Please find below the comment summary on SLP15062-1 Brock Commons Landscape and Civil Works. Respond to each item and return for our record. A resubmission of the Landscape set will be required once all comments have been satisfied.

**Brock Commons Phase 1**  
 6088 Walter Gage Road  
 University of British Columbia

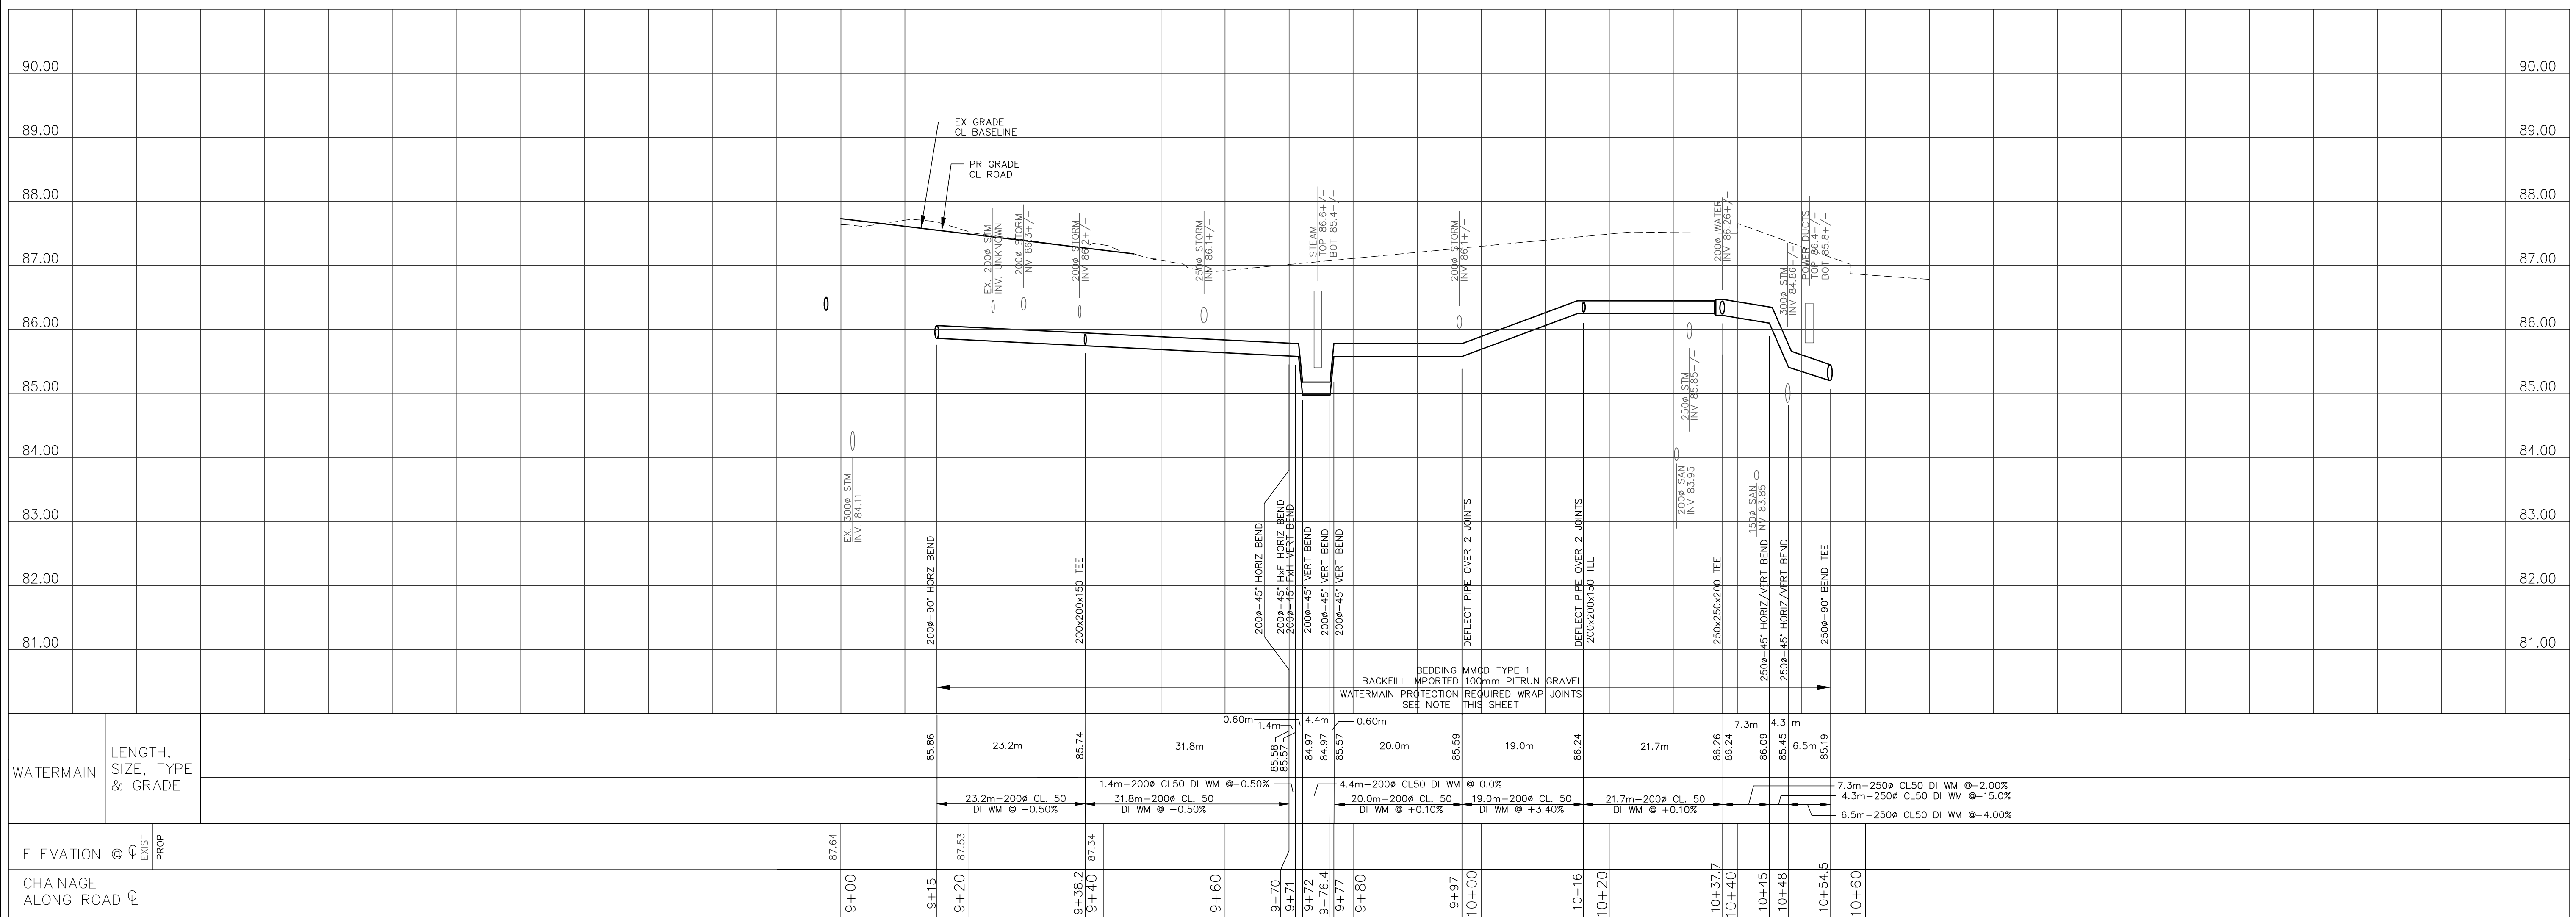
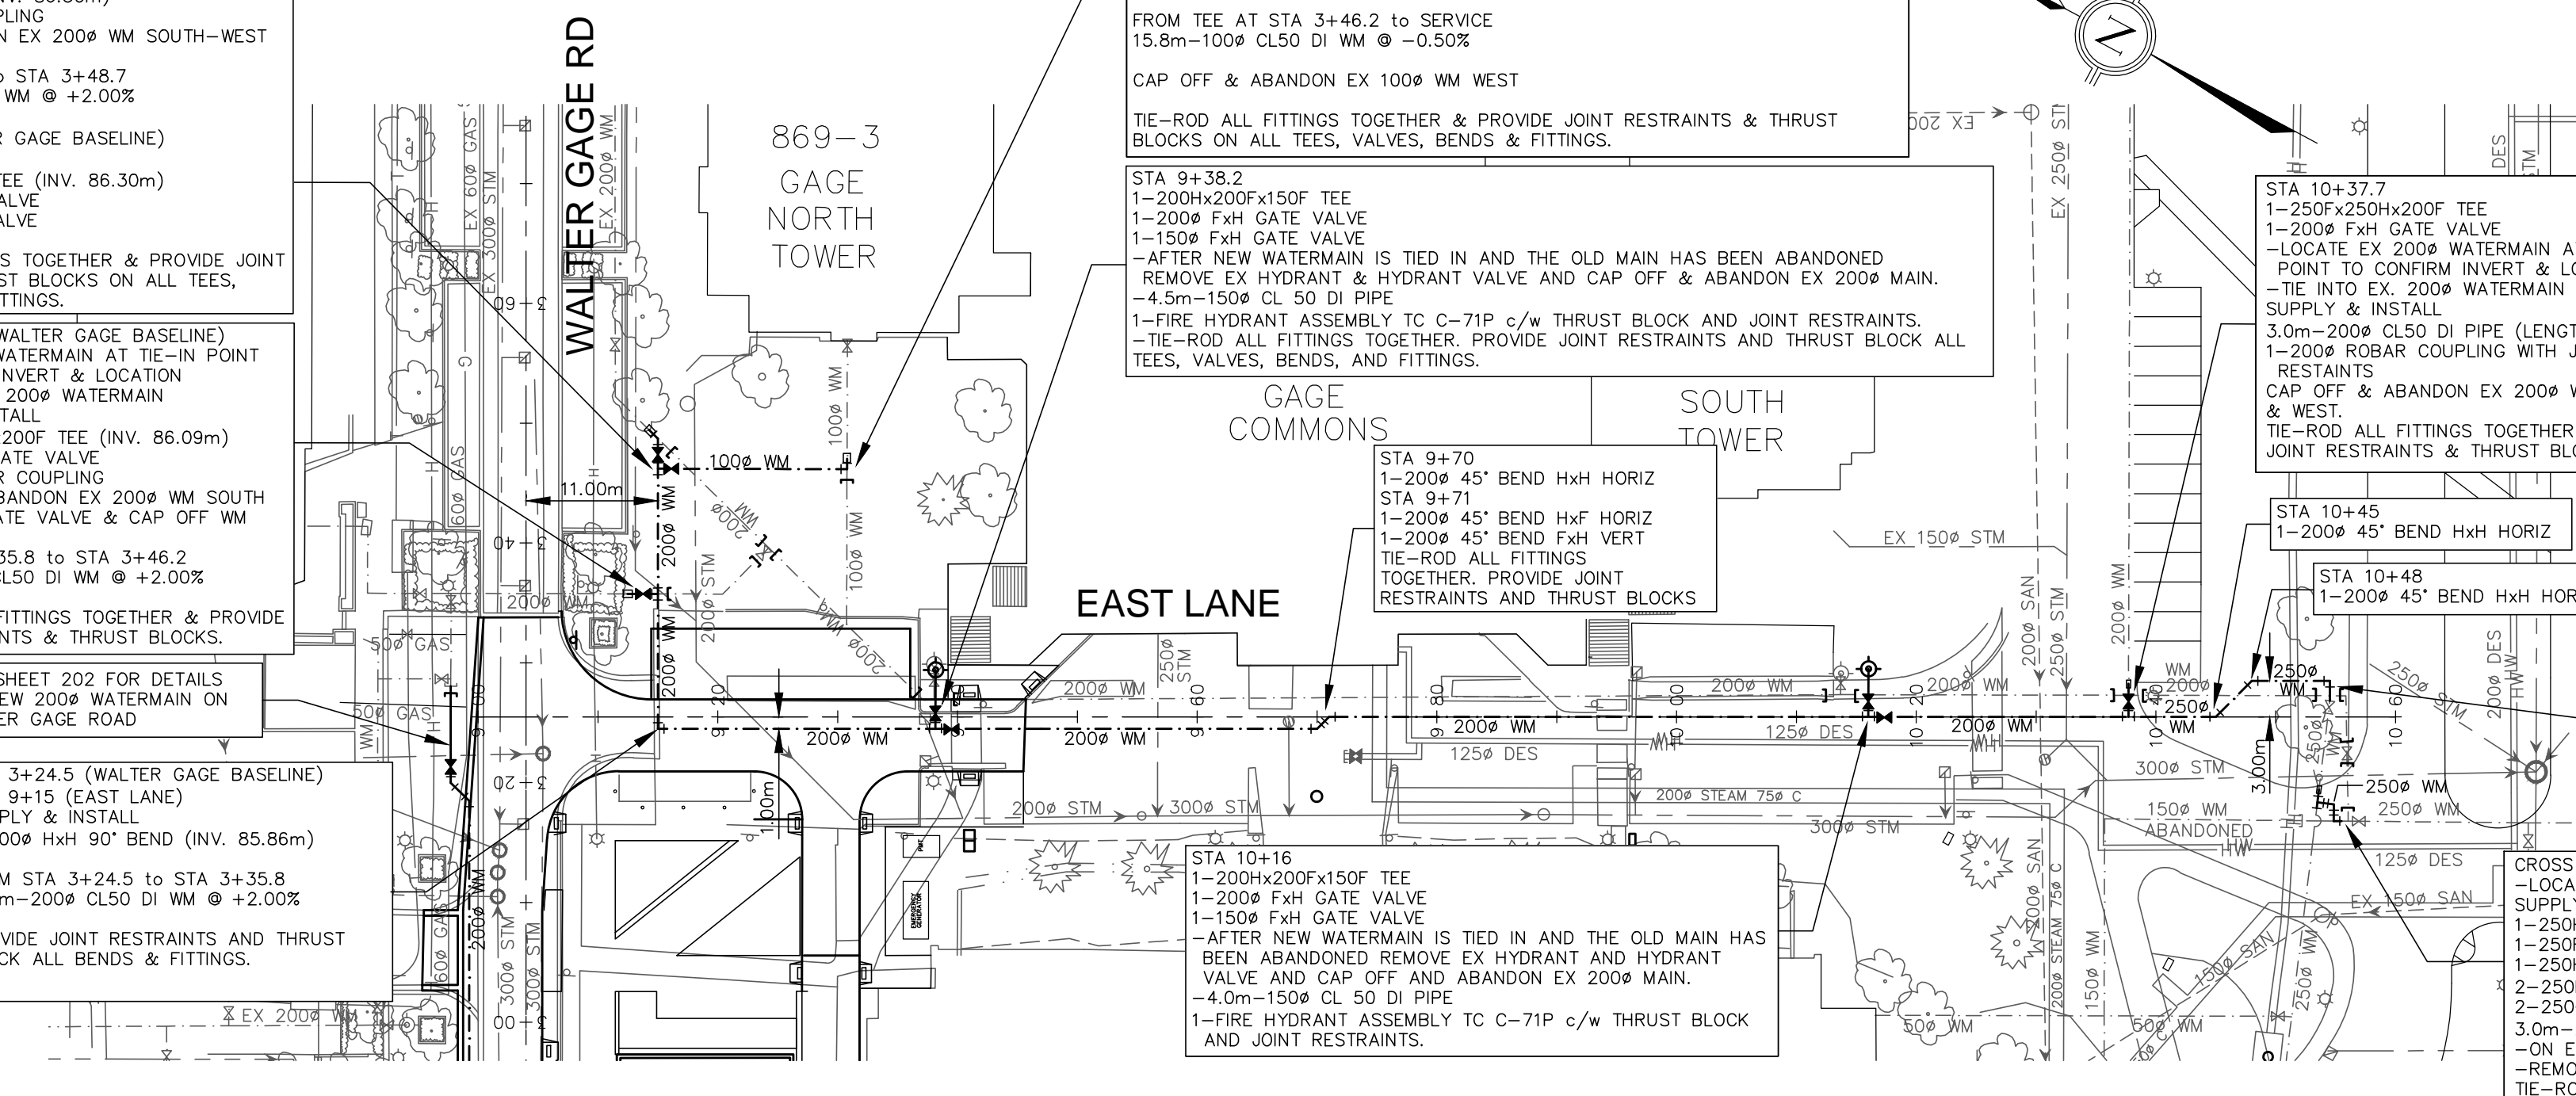
- *Additional Scope: A quote was requested by Energy Water Services for additional work including WM replacement, existing 250 mm DI main tie-in on south end, and existing AC main abandonment. See the mark –up on the attached water map. Contact Kamps Engineering for more information on the current status of this request. If this will be added to the project, we can process this separately as an amendment.*  
*Brock Commons Watermain Replacement Estimate, by Kamps Engineering (an associated email was sent directly to Jenny Liu on 17 Oct. 2016 - a subsequent recommendation email was received from Jenny Liu on 19 October 2016)*
